**Closure of Landside Impermeable Wall
Outline of Change of Implementation Plan Approval Application**

February 22, 2016

Tokyo Electric Power Company

Figure 1. Complete view of Landside Impermeable Wall

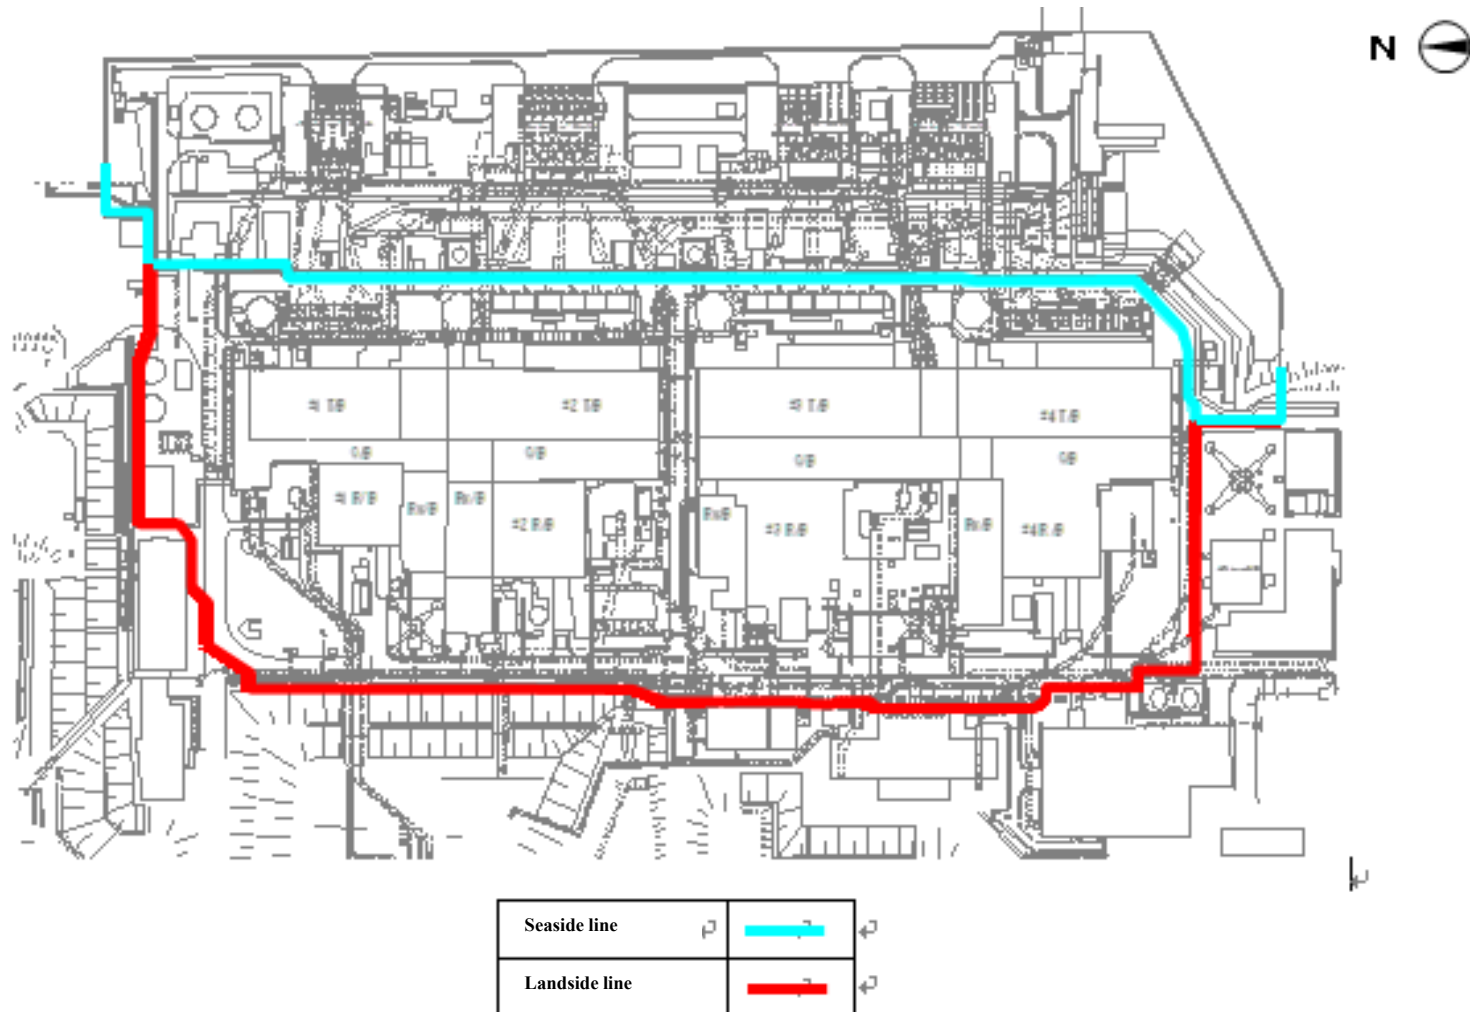
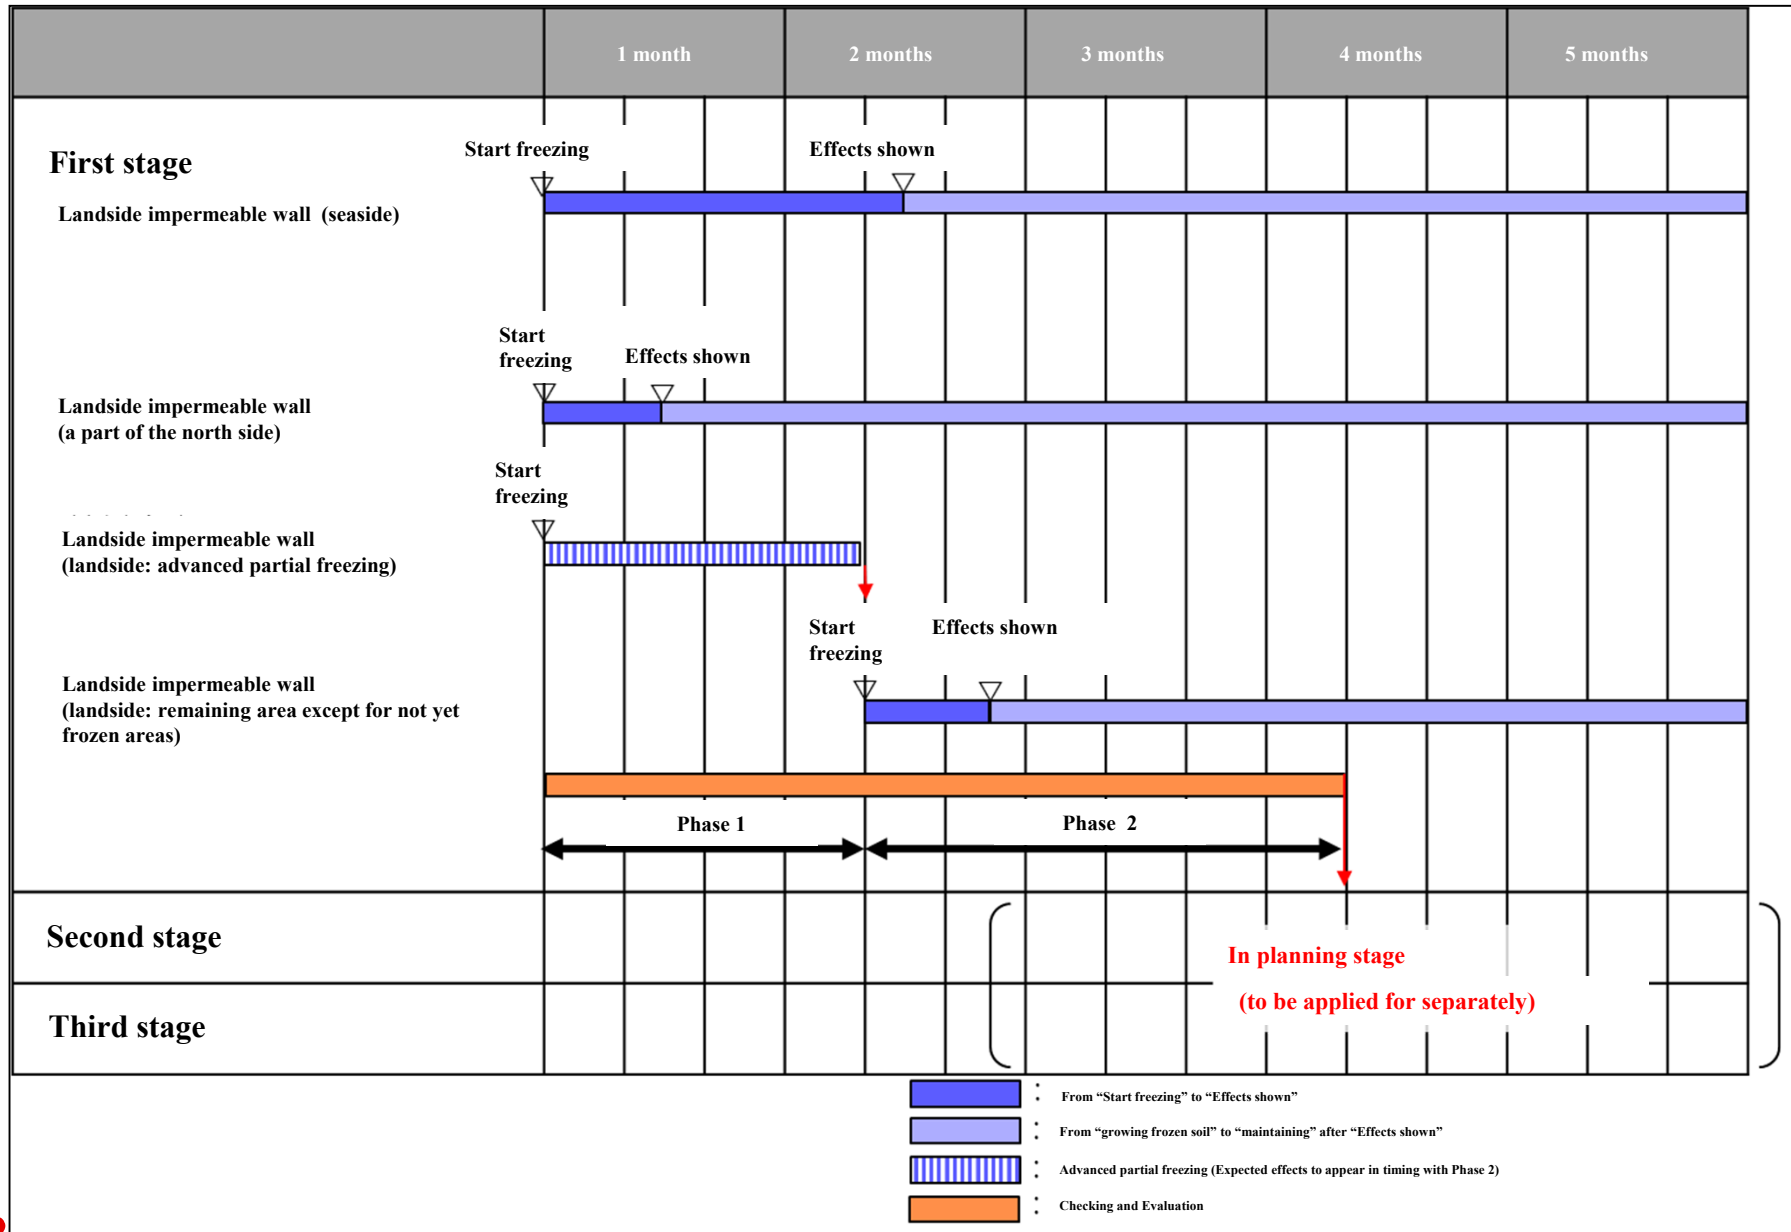
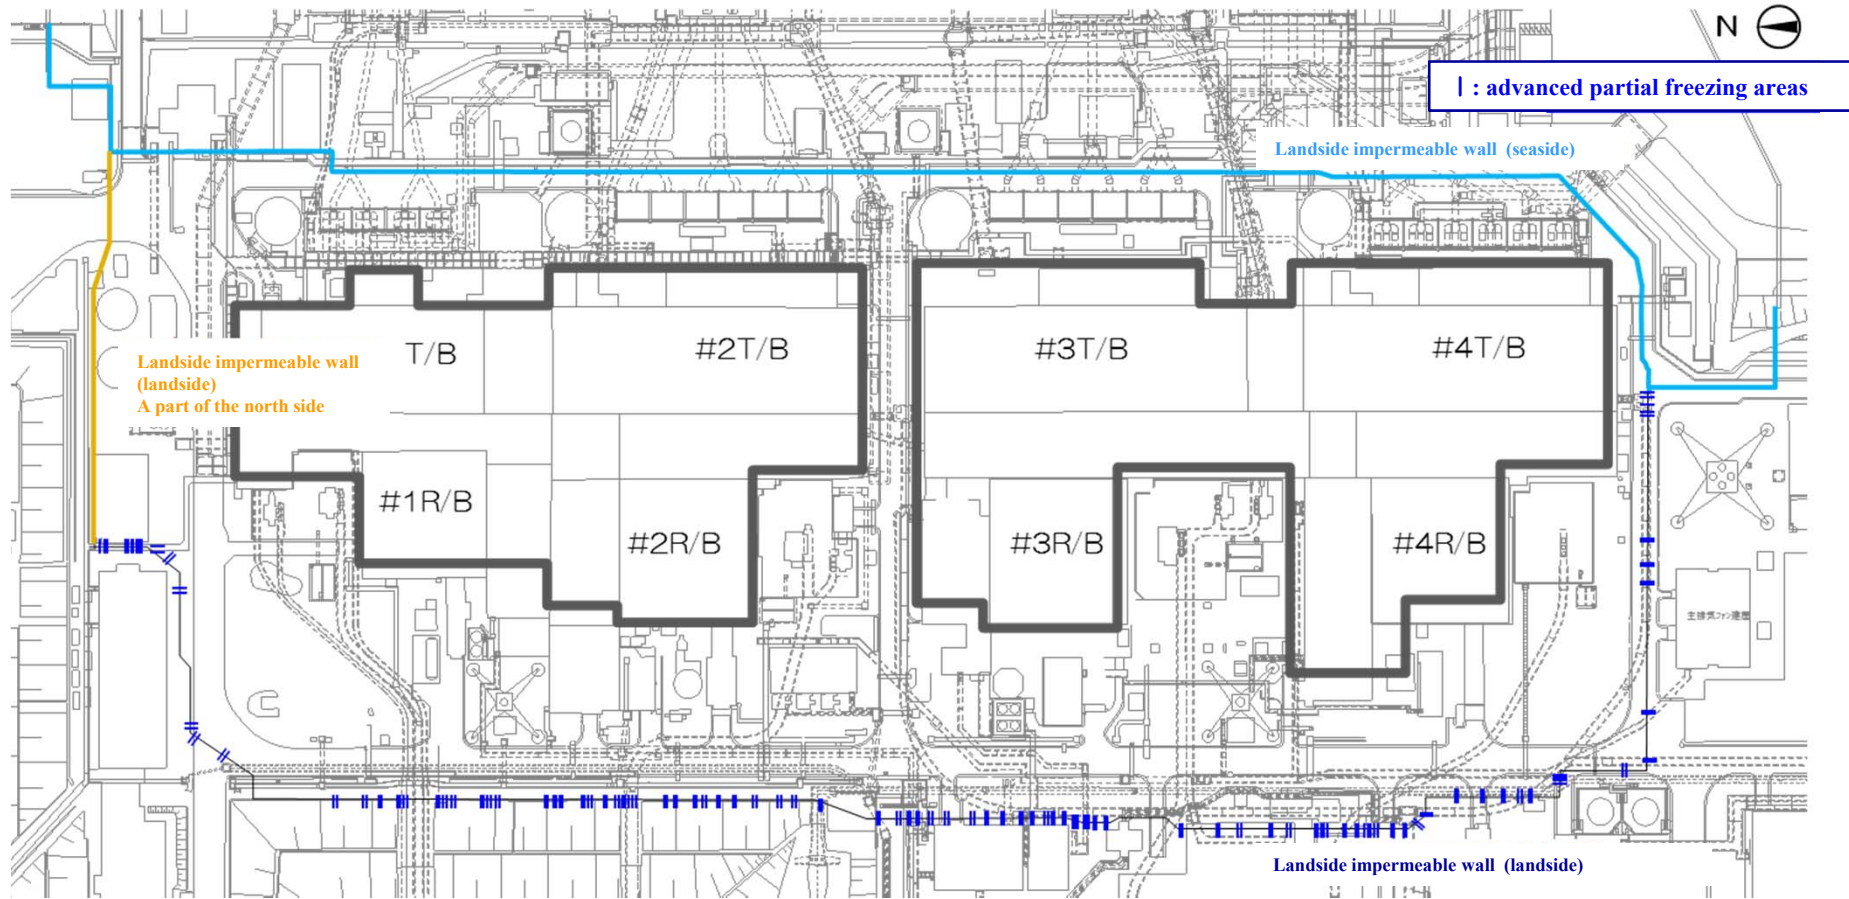
The scope of this application is for closure of the entire seaside line and closure of the landside in stages.
